## ANN ARBOR HISTORIC DISTRICT COMMISSION

### Staff Report

**ADDRESS:** 211 Third Street, Application Number HDC13-208

**APPLICATION:** The applicant seeks HDC approval to construct a 212 square foot second floor on top of the existing rear wing of the house; add a skylight; add a window to the rear elevation on the first floor; and replace part of the front porch and two basement walls, including the installation of a new egress window.

0 Proposed  
Basement Plan

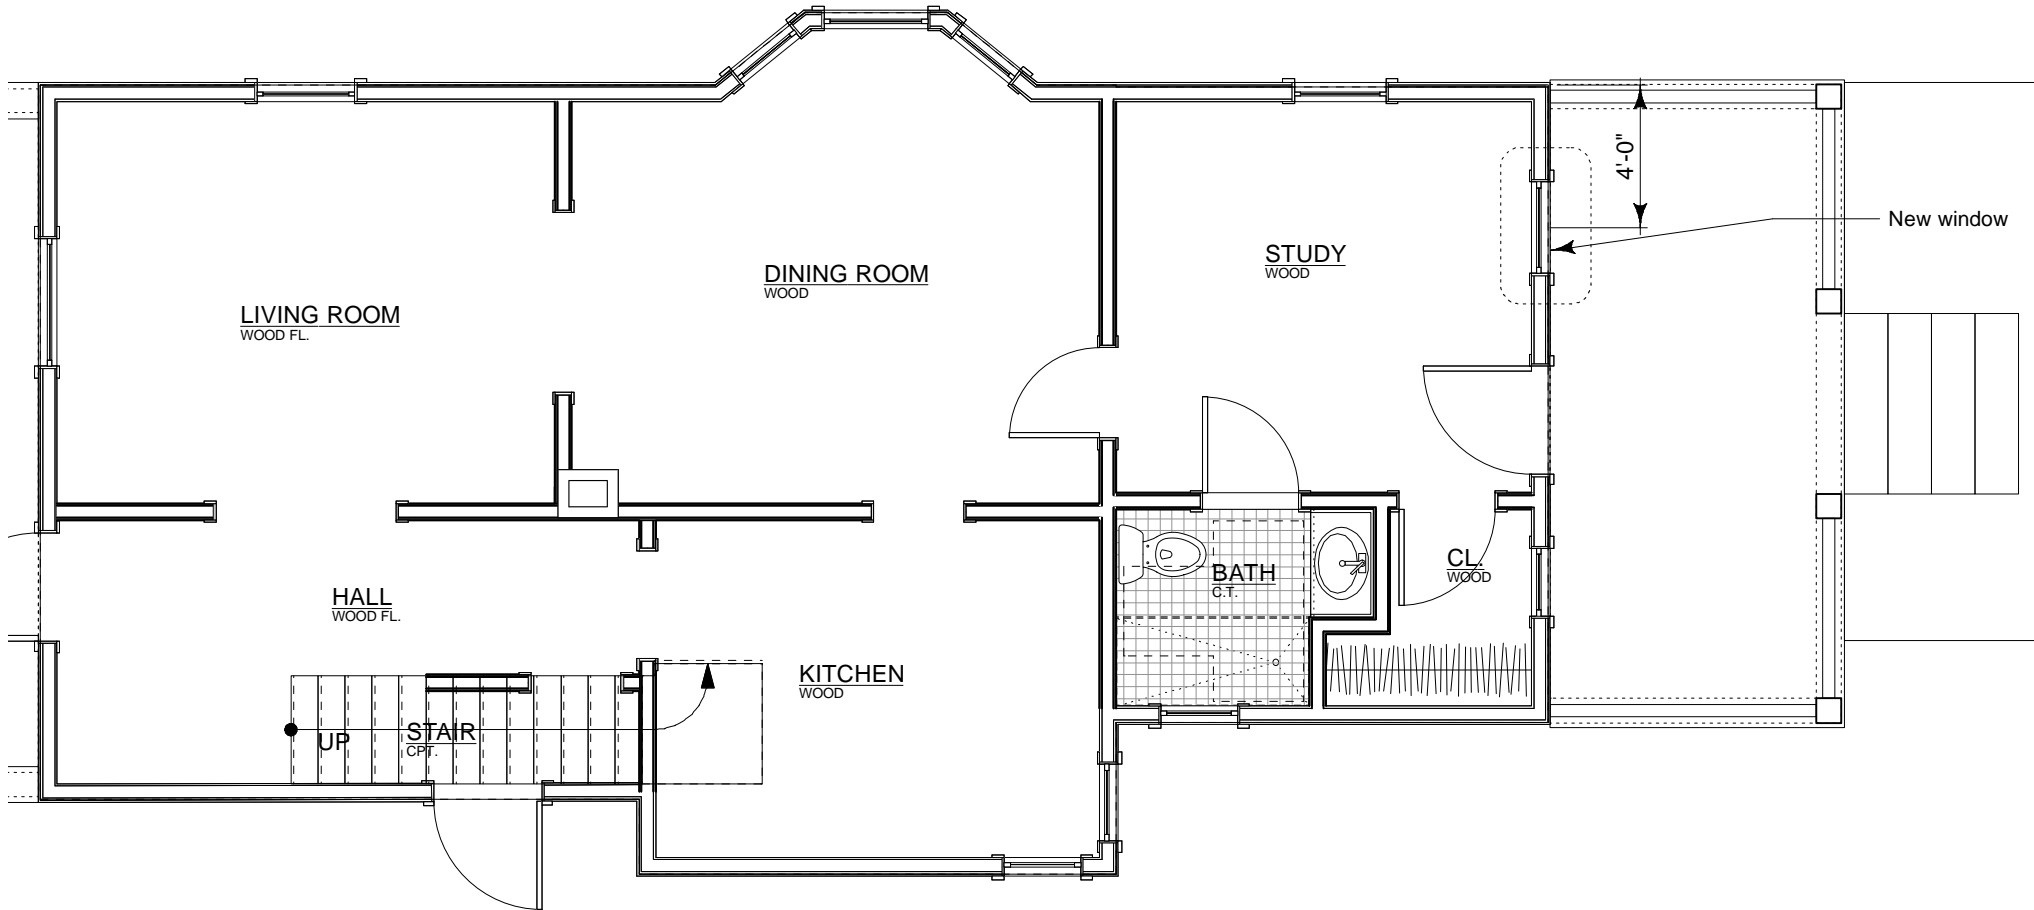
3. The south wall and the southwest corner of the basement foundation, along with the southernmost wall of the front porch, were replaced about a decade ago. The original foundation consisted of rusticated block, while the new sections are standard CMU. The front porch has a mix of the two, which is unfortunate. The applicant must replace the remaining basement walls due to structural integrity issues, and proposes to match the CMU from the earlier replacement. The front porch would be treated with a stucco parge coat for a more finished appearance than plain block. Given the mix of block styles already found on the house, staff believes this is an appropriate approach. Though closer

to the front of the house than preferred by staff, the location of the basement egress window is appropriate since the alternatives are either close to the existing basement stairs or under the bay window on the north elevation. The window well would be constructed of concrete block and its size is not excessive.

**1** Proposed  
Roof Plan

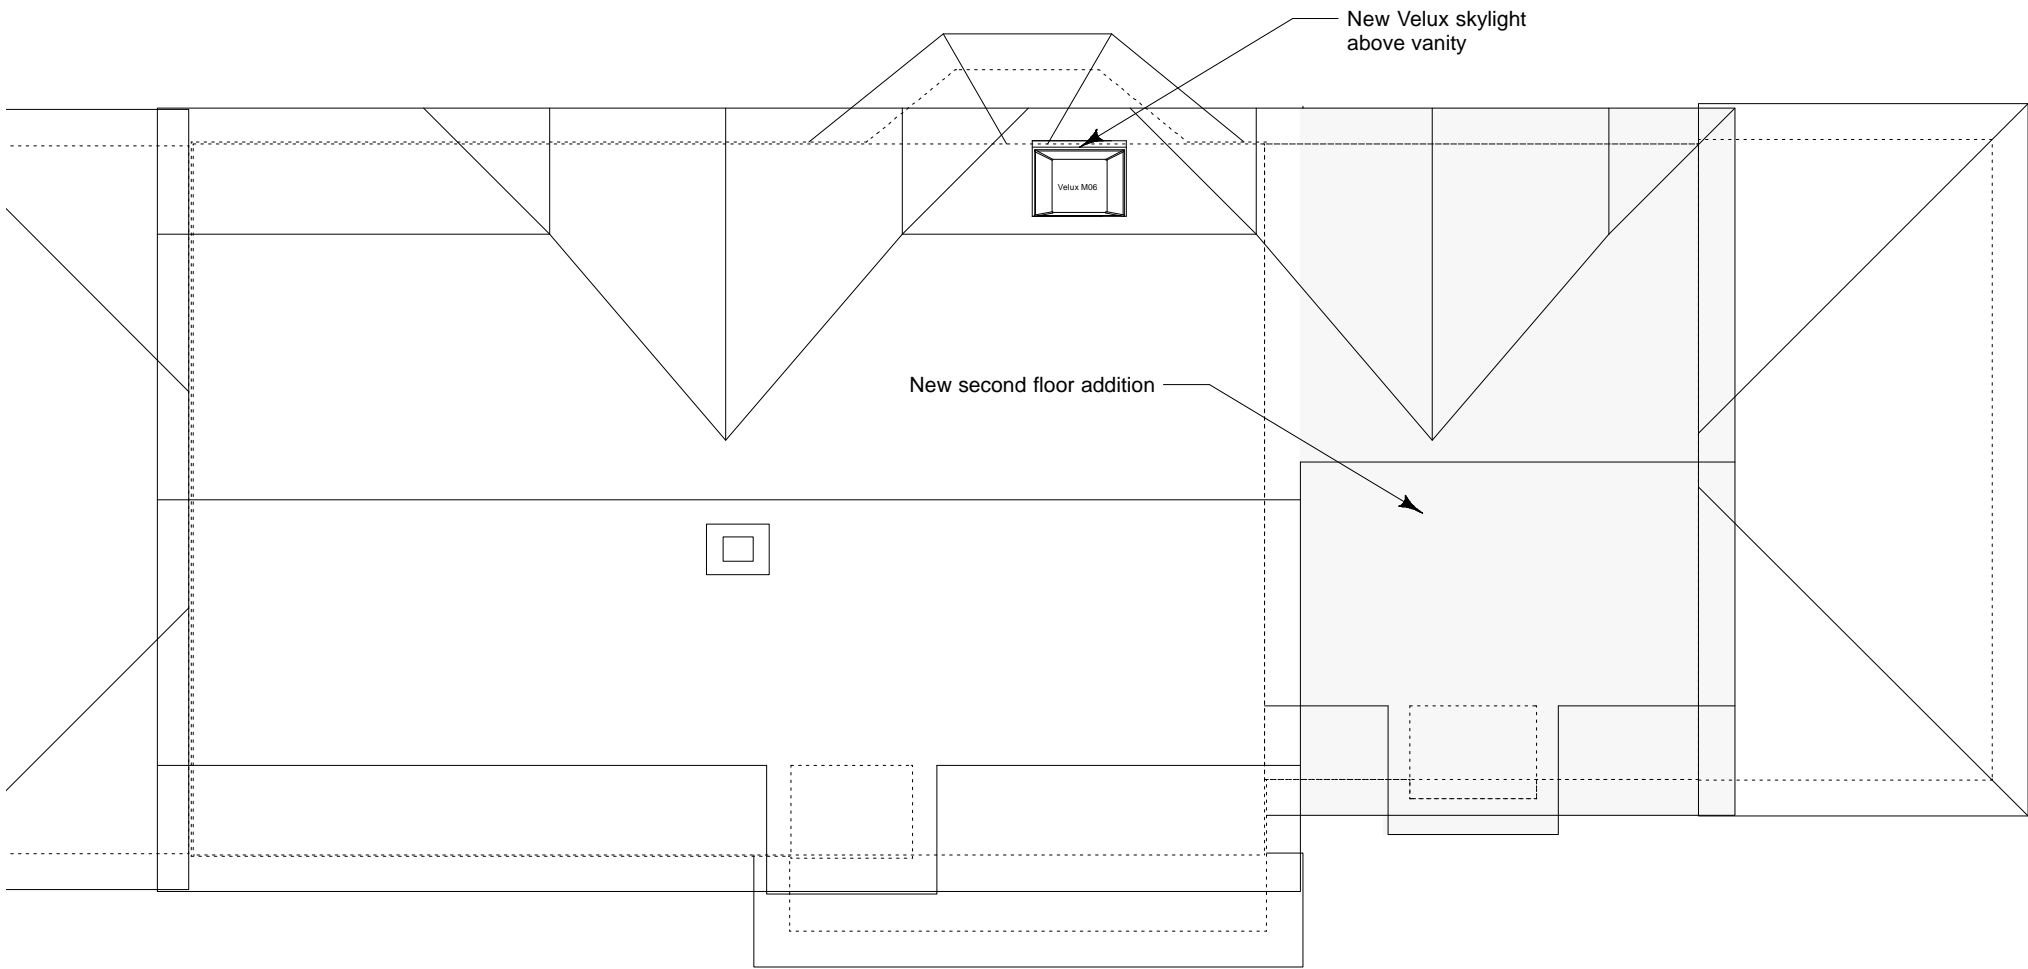
1. The proposed addition would increase the size of the house from 1455 square feet to 1667 square feet, a 14% increase. It would sit on top of the existing 1940s-era rear addition, but not on top of the rear covered porch. The north elevation would feature a gambrel cross-gable similar in proportion to one on the existing north elevation. It would be distinguished by an 8" wide trim board along its base, and would not have corner returns like the existing gable. It would also feature a half-circle window, a design element not present on the original house but compatible with the Dutch colonial revival design. This window is repeated on the gambrel-roofed rear elevation of the addition, atop three mullioned casement windows. The south elevation of the addition would feature a shed-roof dormer with a casement window. A new velux skylight on the north face of the roof would sit between the existing and proposed dormers.
